UNITED STATES PATENT AND TRADEMARK OFFICE

APPLICATION NO.	FILING DATE	FIRST NAMED INVENTOR	ATTORNEY DOCKET NO.	CONFIRMATION NO.
10/025,307	12/19/2001	Paul Joseph Datta	15,701	3399

Office Action Summary

DETAILED ACTION

Fig. 2

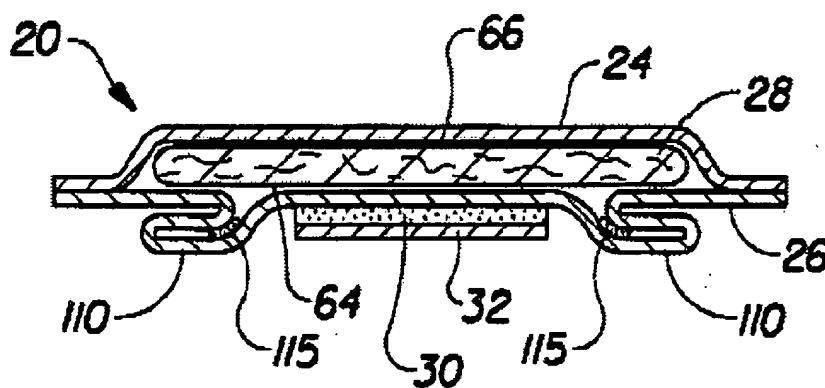
Regarding claims 1 and 2, Milby, Jr. *et al.* teach a diaper (20) comprising a substantially liquid-impermeable stretchable outer cover (26) configured to provide a first level of elongation (Abstract);

a liquid-permeable stretchable (Col. 5, lines 32-61, describing topsheet materials that are inherently stretchable) top surface (24) attached to said stretchable outer cover (26); said stretchable top surface (24) having a first zone (entire topsheet) that is configured to provide a second level of elongation that is less than the first level of elongation;

an absorbent body (28) located between said stretchable outer cover (26) and said stretchable top surface (24)(see Fig. 2, below).

Regarding claim 10, Milby, Jr. *et al.* teach a first zone (24) that overlaps the absorbent body (28)(Fig. 2).

Regarding claim 16, Milby, Jr. *et al.* teach a back sheet (26) that elongates more than the topsheet (24) when the absorbent body (28) expands (Fig. 2).
